Catalog Correction NoticeIssue Date
April 3, 2017

No. 2017002DE

" Mobile Robots LD series Datasheet " < Publication in February, 2017 > < Catalog number I828-E1-01 >
" Mobile Robots LD series Pamphlet " < Publication in February, 2017 > < Catalog number I825-E1-01 >

Datasheet: Page 3 AIV Specifications: Maximum rotation speed

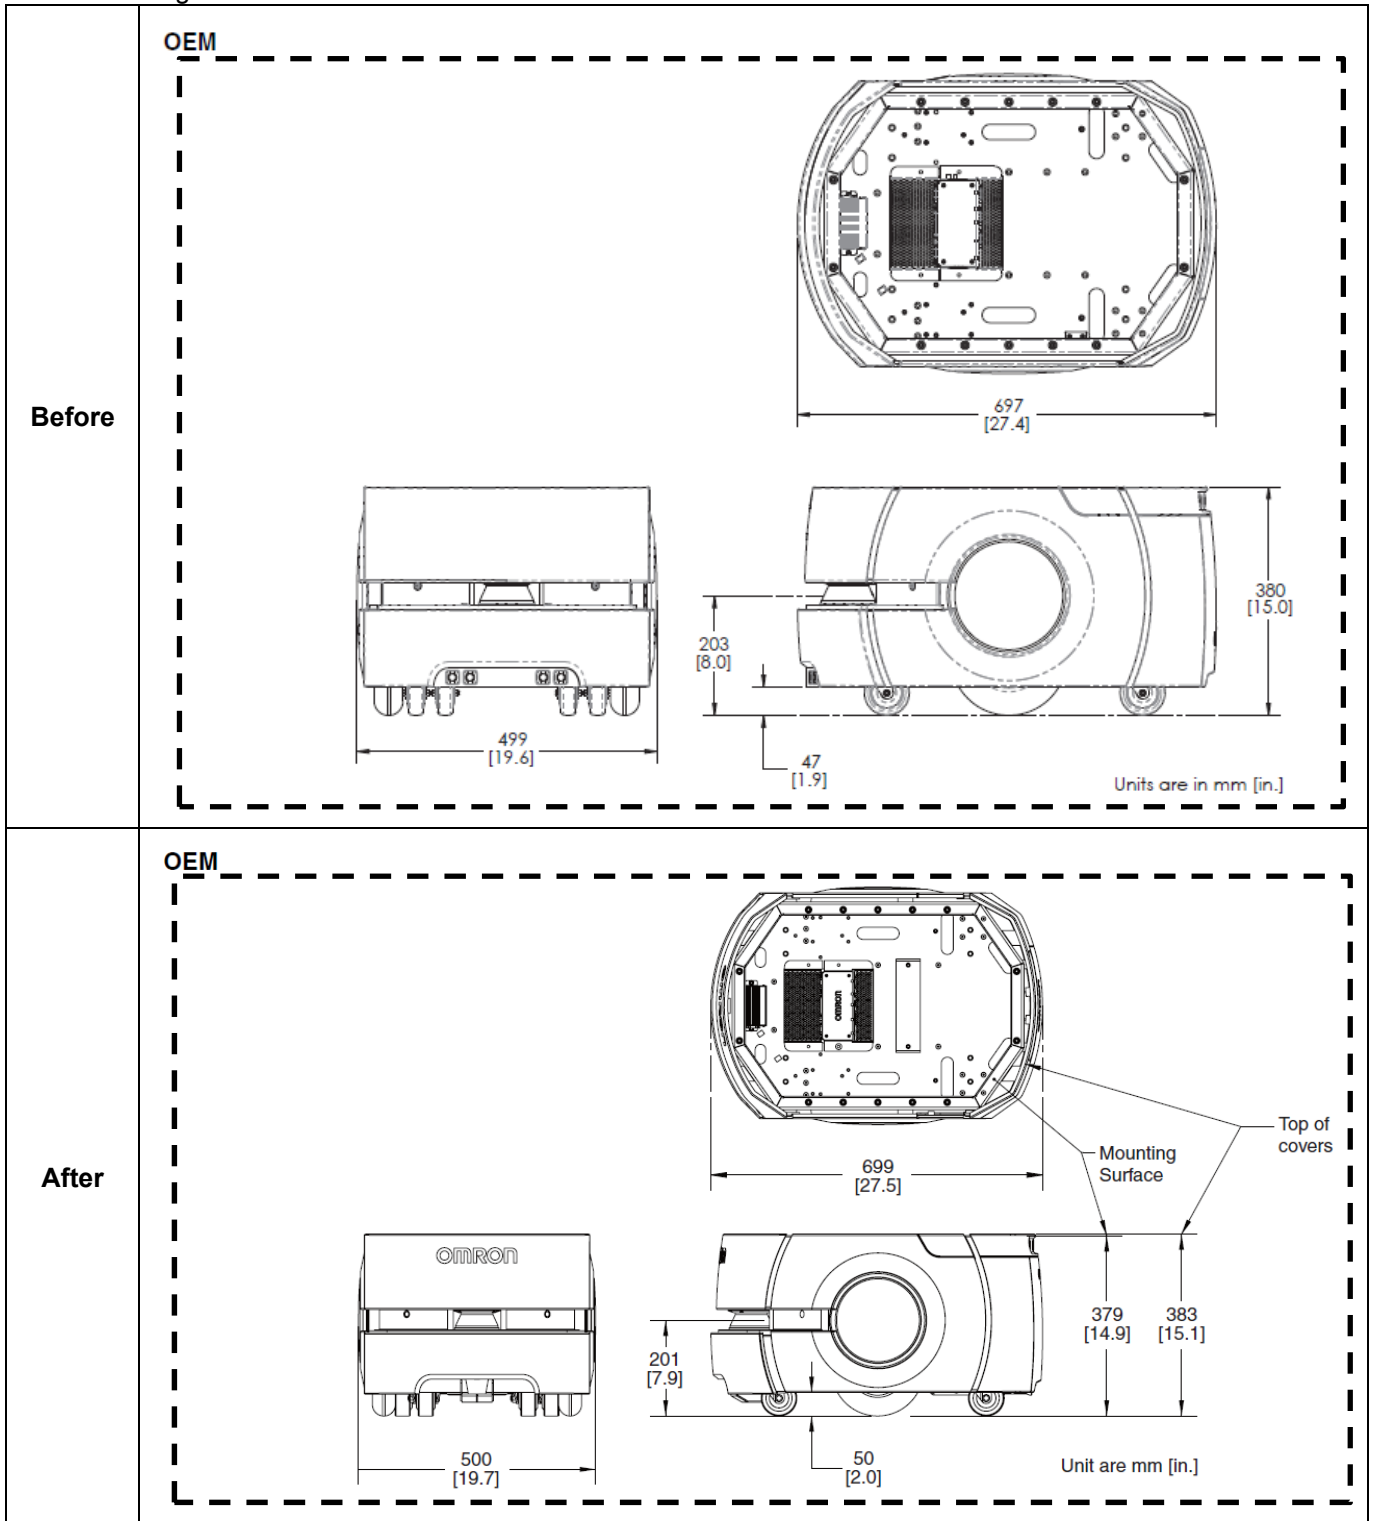
Before	OEM 37030-□□□□□□: 300°/s 37040-□□□□□□: 225°/s Cart Transporter 37140-□□□□□□/37160-□□□□□□: 180°/s
After	OEM 37030-□□□□□□: 180°/s 37040-□□□□□□: 180°/s Cart Transporter 37140-□□□□□□/37160-□□□□□□: 100°/s

Datasheet: Page 7 Dimensions

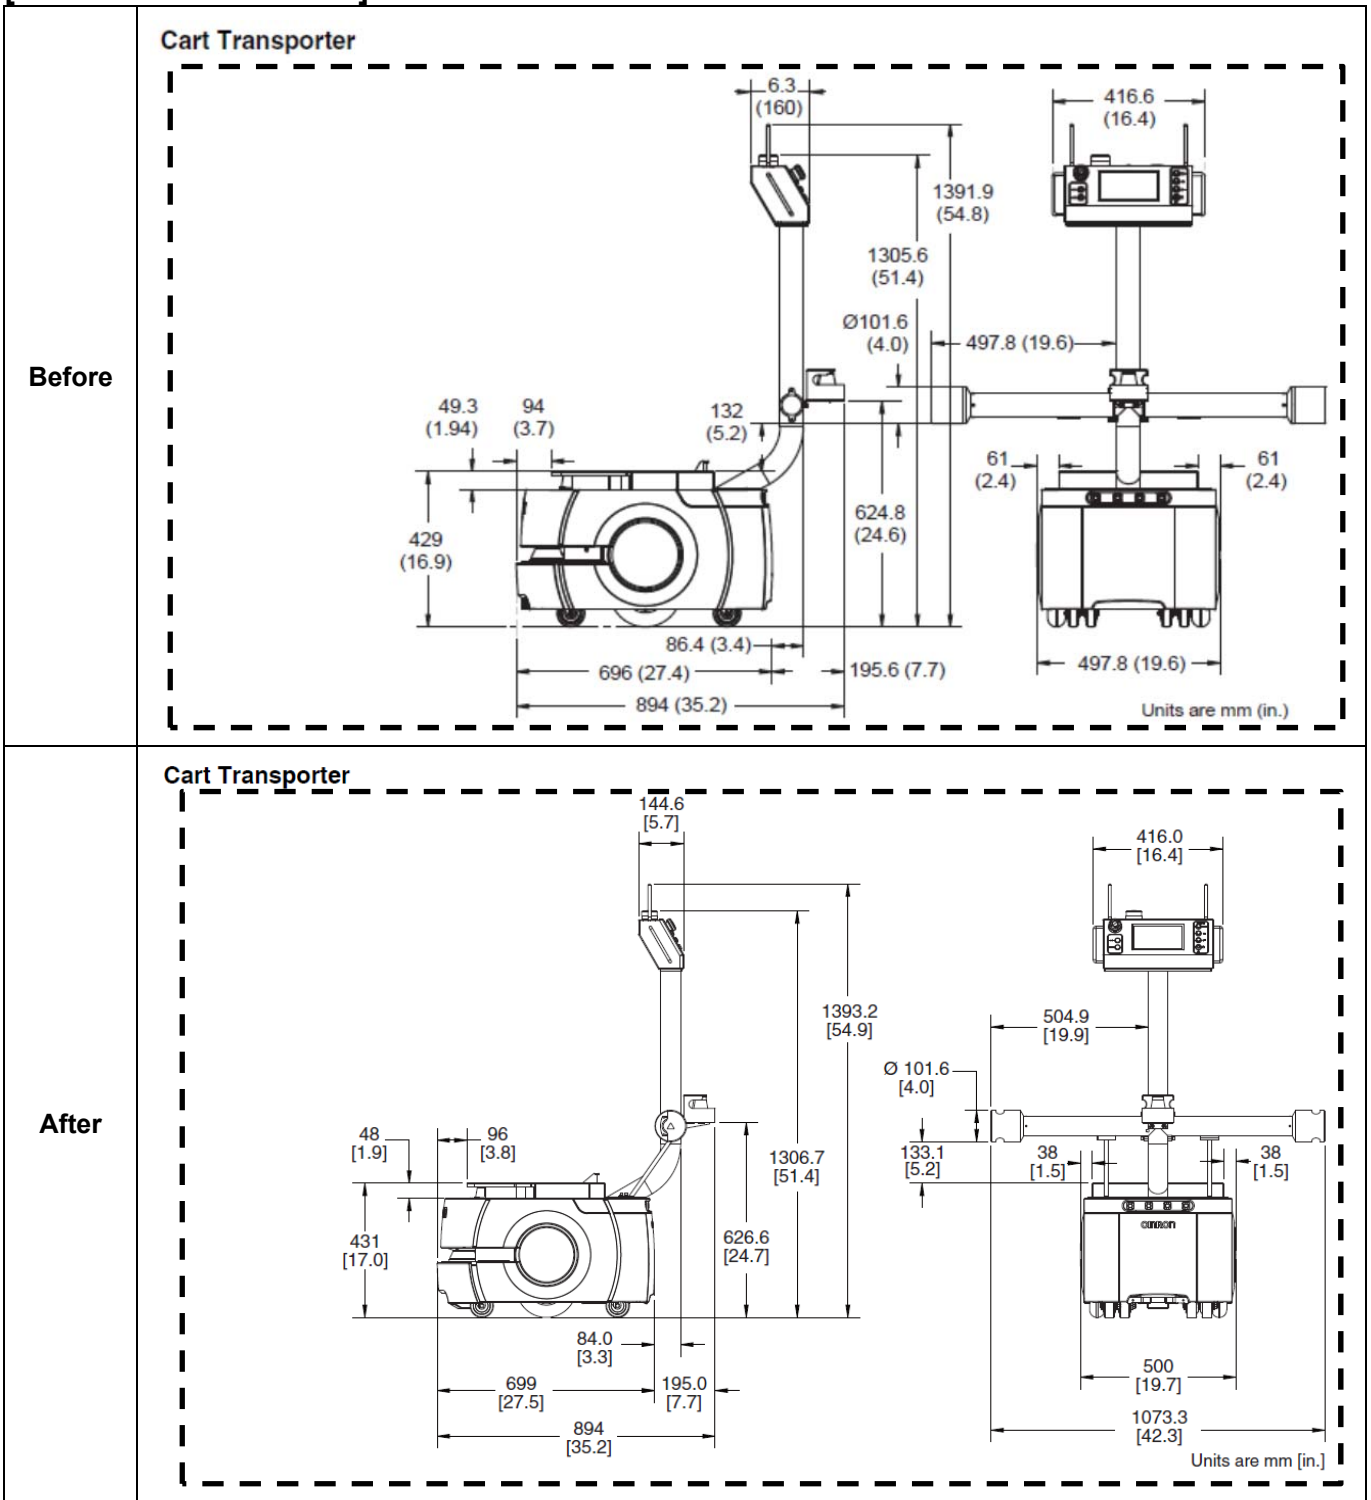
[Content of correction]
